**Landscape Review Committee**  
**Community Development Center, 231 NE 5<sup>th</sup> Street**  
**May 15, 2019**  
**12:00 PM**

**DATE:** May 15, 2019  
**TO:** Landscape Review Committee Members  
**FROM:** Jamie Fleckenstein, Associate Planner  
**SUBJECT:** Street Tree Removal Application (L 45-18)

DATE: May 15, 2019  
TO: Landscape Review Committee Members  
FROM: Jamie Fleckenstein, Associate Planner  
SUBJECT: Landscape Plan Application (L 7-19)

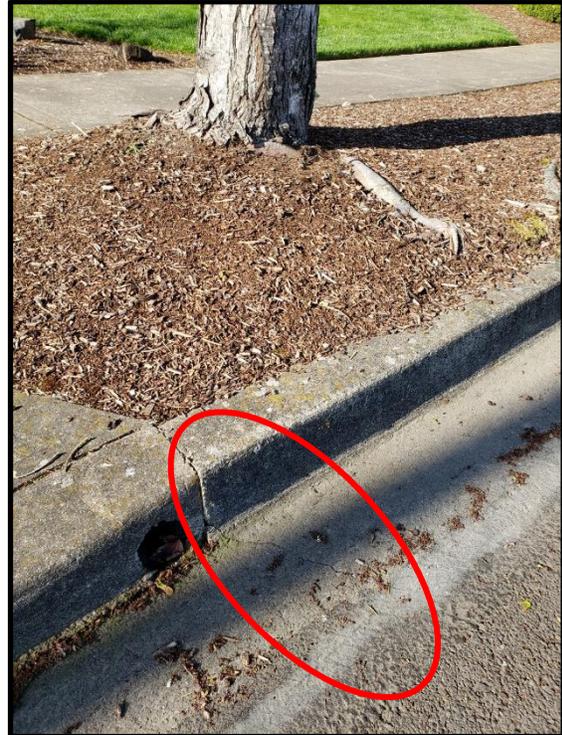
The applicant has requested the removal of two (2) street trees due to conflict with public improvements. The trees are maple varieties (*Acer truncatum* var.) are approximately seven (7) and eight (8) inches DBH (diameter at breast height) respectively. The trees are located in a five (5) foot wide planter strip and appear in good health and condition. Both trees appear to have been planted shallowly, as evidenced by buttress roots being above sidewalk grade, and exhibit extensive surface rooting.

The westernmost street tree adjacent to the property is planted within five (5) feet of the water meter serving the property. The City standard spacing from a water meter is 10 feet. The applicant has expressed concern about root damage to the water service to her property. An arborist's report for this tree recommends removal to prevent further damage and water line breakage.

Figure 4: Proposed Landscape Plan

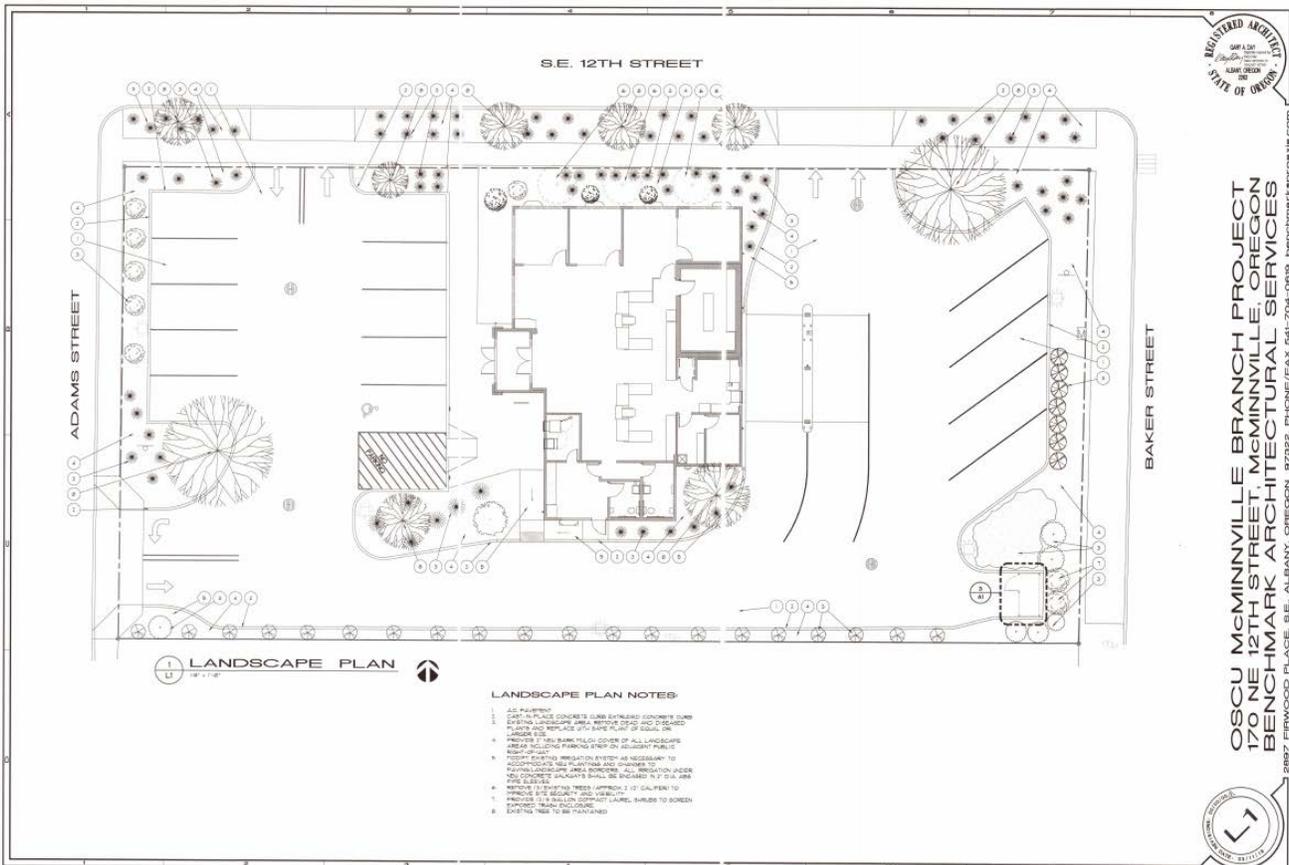
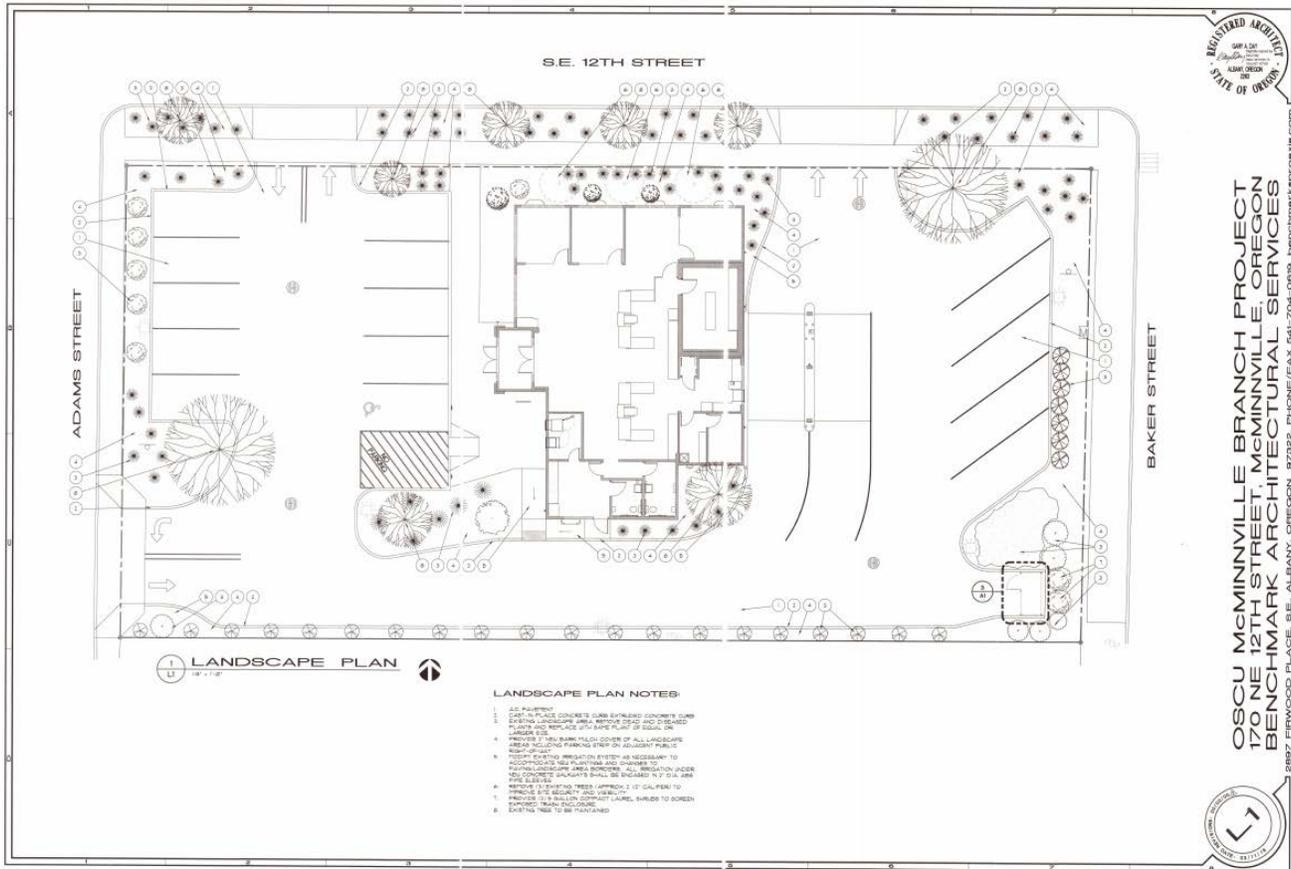
A building permit has been applied for to remodel an existing building (formerly a bank and most recently a retail store) to re-open as a new Oregon State Credit Union branch. The remodel of the building is limited mostly to the interior of the building, and expansion of the footprint of the structure is within previously the approved roofline of the building. No new impervious surface is proposed. Because the previous uses of the site included a bank and retail store, no major changes to the overall site plan are proposed. The drive-up banking lanes are being reconfigured to add a second lane. Otherwise, the location and configuration of existing landscape, parking, and drive isles are remaining generally the same. **See Figure 3: Site Plan.** The landscape plan addresses landscaping around the solid waste enclosure which is being updated, and around portions of the perimeter of the building. **See Figure 4: Landscape Plan.**

Because no new impervious surface is being created, no new additional landscape areas are required on the site. The landscape plan was submitted to address screening of a trash enclosure and a proposed revision to a previously approved landscape plan for the site.

**L 13-10 Approved Landscape Plan****Proposed Landscape Plan**

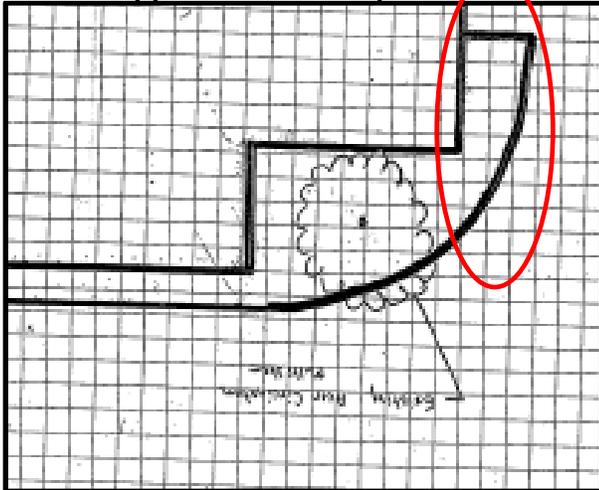
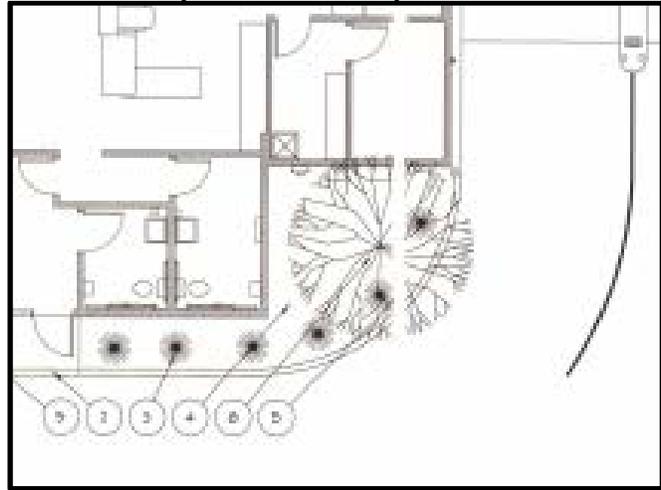
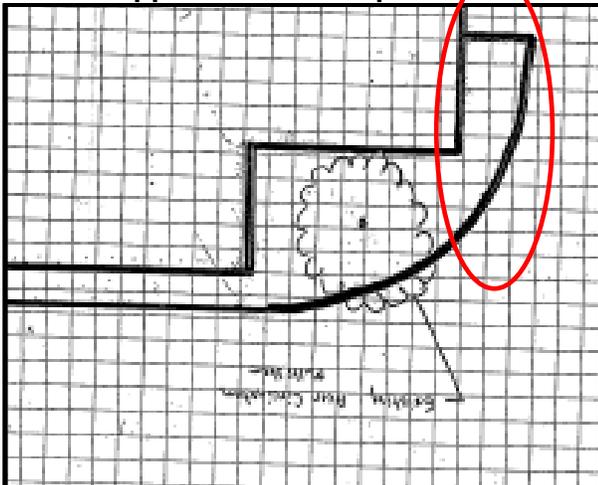
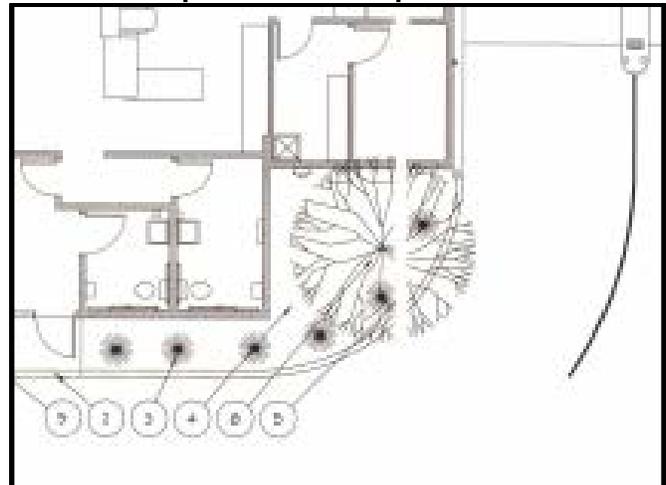
The subject site is zoned C-3 (General Commercial). The Landscaping chapter of the McMinnville Zoning Ordinance requires that at least seven (7) percent of the gross area of a site being developed be landscaped (Section 17.57.070(A)(2) (Area Determination – Planning Factors)). Although the application does not indicate the percentage of landscape provided, the amount of landscaping removed from the site through reconfiguration of the drive aisle is not substantial enough to reduce the total percentage below the required seven (7) percent.

**L 13-10 Approved Landscape Plan**

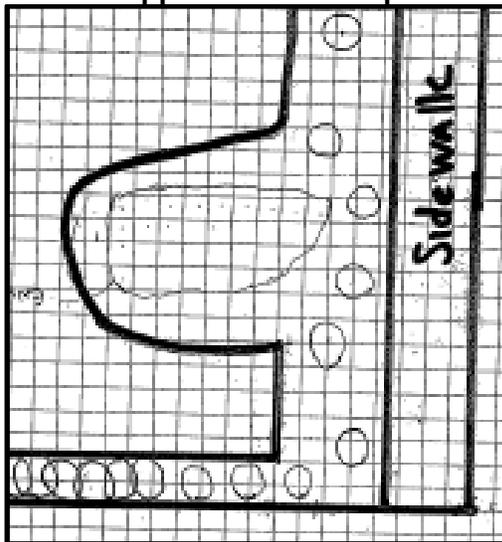
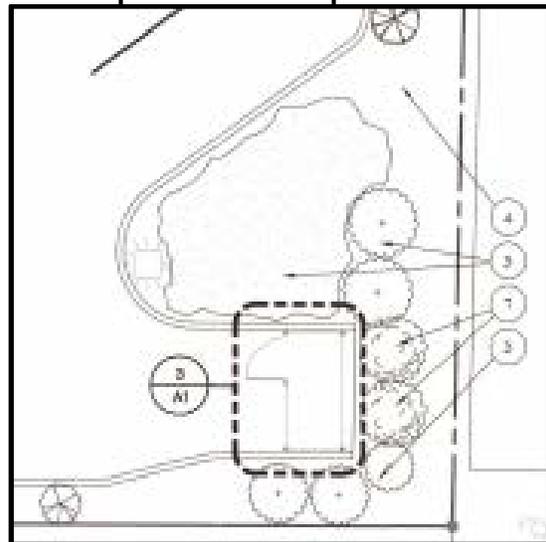
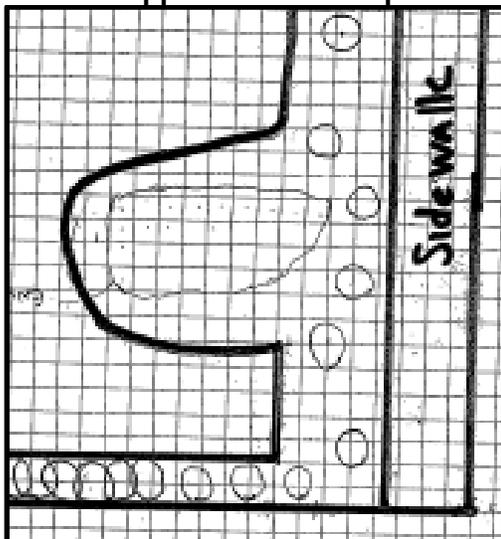
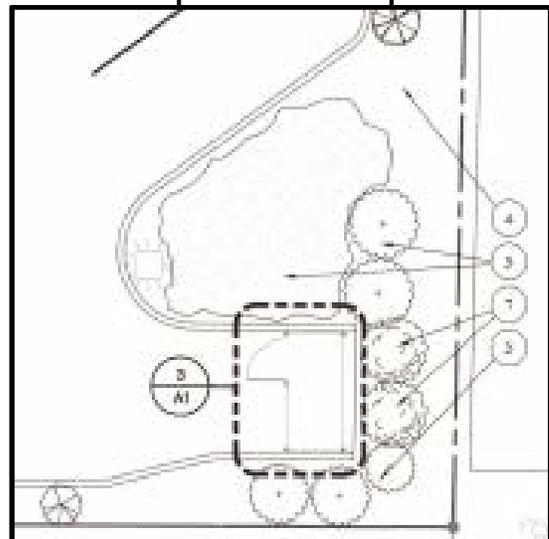
While the existing landscaping is generally being retained and replaced in kind throughout the site, there are two areas where significant changes to the approved landscape plan are proposed. The first area is along Baker Street, where the trash enclosure is located. The enclosure itself is being updated to reflect

the materials of the building, and new landscaping is proposed around the enclosure, and new evergreen planting (Laurel) is proposed to fill in gaps in the vegetative hedge obscuring the trash enclosure from view.

**L 13-10 Approved Landscape Plan**

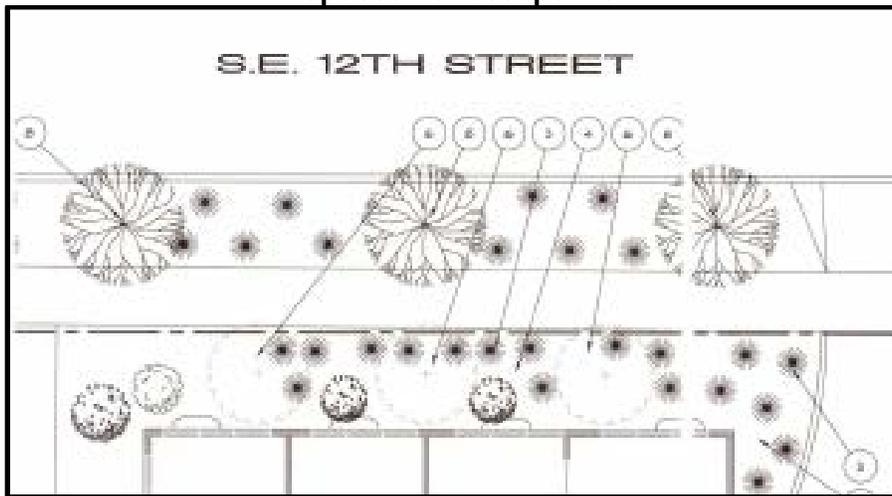
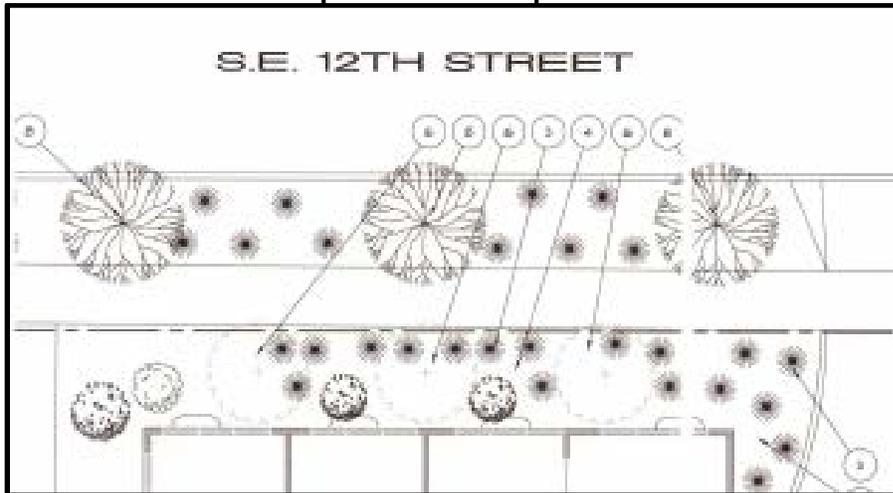
The second area with a significant change from the original landscape plan is the north side of the building, where three (3) mature Japanese Maples are being proposed for removal due to security and visibility concerns. A row of windows along the north side of the building is blocked by the foliage from the trees, limiting visibility in and out of the windows. Additionally, applicant has cited concern over the security of the planting area on the north side of the building. The Bloodgood Maples are small trees, with dark foliage. On the north side of the building, where the planting area is often in shade, it gives the appearance of a dark and insecure space next to pedestrian and vehicular access into the site. The overhead canopy along 12<sup>th</sup> Street is very low due to the adjacent Kwanzan Cherry street trees, and it provides a sense of confinement and enclosure. Because of the perception of an unsafe space and

The second area with a significant change from the original landscape plan is the north side of the building, where three (3) mature Japanese Maples are being proposed for removal due to security and visibility concerns. A row of windows along the north side of the building is blocked by the foliage from the trees, limiting visibility in and out of the windows. Additionally, applicant has cited concern over the security of the planting area on the north side of the building. The Bloodgood Maples are small trees, with dark foliage. On the north side of the building, where the planting area is often in shade, it gives the appearance of a dark and insecure space next to pedestrian and vehicular access into the site. The overhead canopy along 12<sup>th</sup> Street is very low due to the adjacent Kwanzan Cherry street trees, and it provides a sense of confinement and enclosure. Because of the perception of an unsafe space and visibility issues the applicant has proposed removing the three (3) Bloodgood Maples without replacement.

**Figure 3: Applicant's Site Plan**

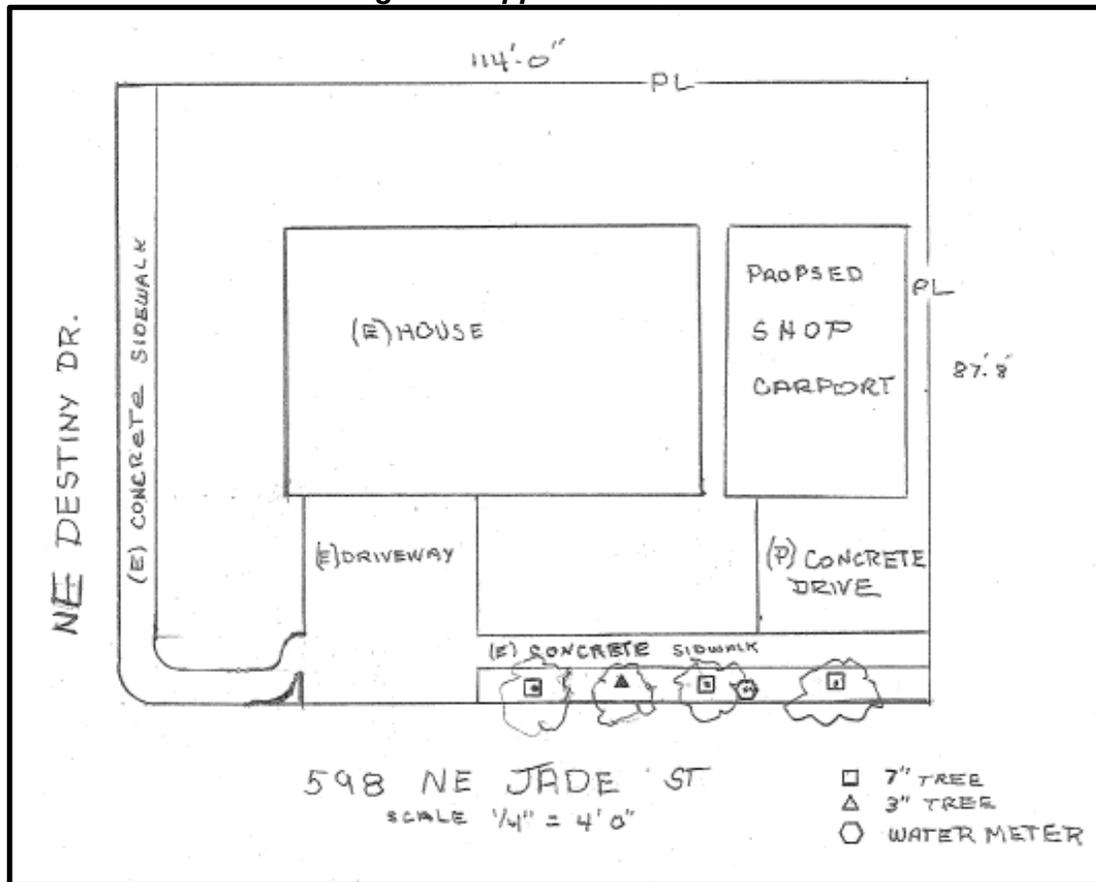
The applicant has requested the removal of one (1) street tree due to conflict with an approved development project. The property owner is proposing to build a new shop building on his property with a second driveway access that would enter the property from Jade Street and access the new structure. **See Figure 3: Applicant's Site Plan.** As part of the development project, the applicant has applied for and received a permit for the construction of a second driveway access to the subject property. The street tree in question is located in the planter strip where the new driveway is proposed.

**Figure 3: Applicant's Site Plan**

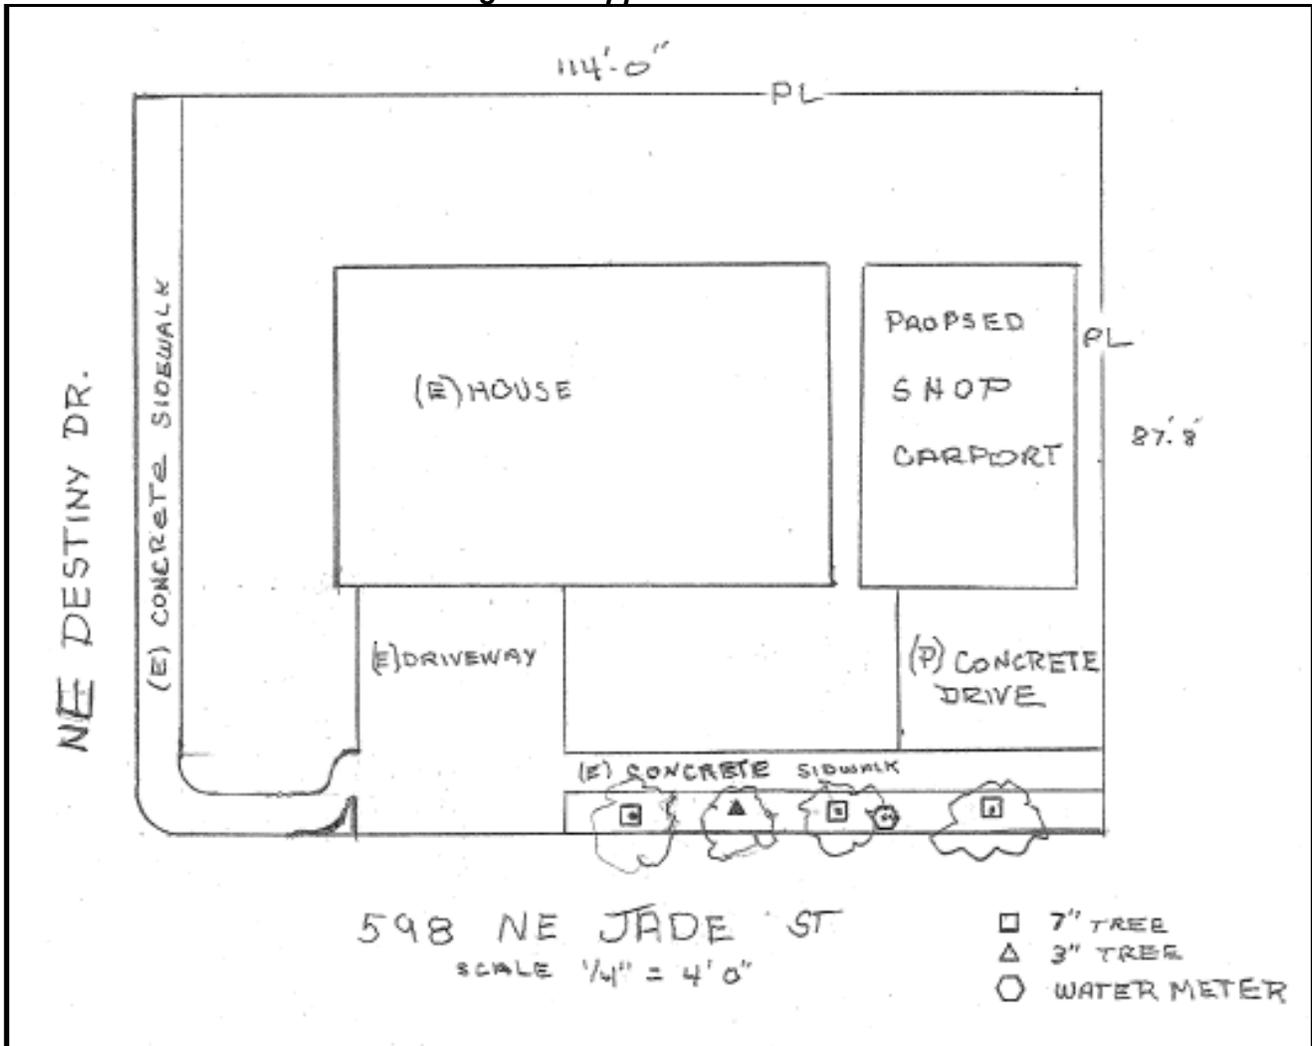
The applicant has requested the removal of one (1) street tree due to conflict with an approved development project. The property owner is proposing to build a new shop building on his property with a second driveway access that would enter the property from Jade Street and access the new structure. **See Figure 3: Applicant's Site Plan.** As part of the development project, the applicant has applied for and received a permit for the construction of a second driveway access to the subject property. The street tree in question is located in the planter strip where the new driveway is proposed.

The street tree requested for removal is planted in the planter strip adjacent to the property where the driveway apron for the proposed driveway would be located. A Public Works permit has been approved, granting the applicant authority to construct a second curb cut and driveway access into the property.
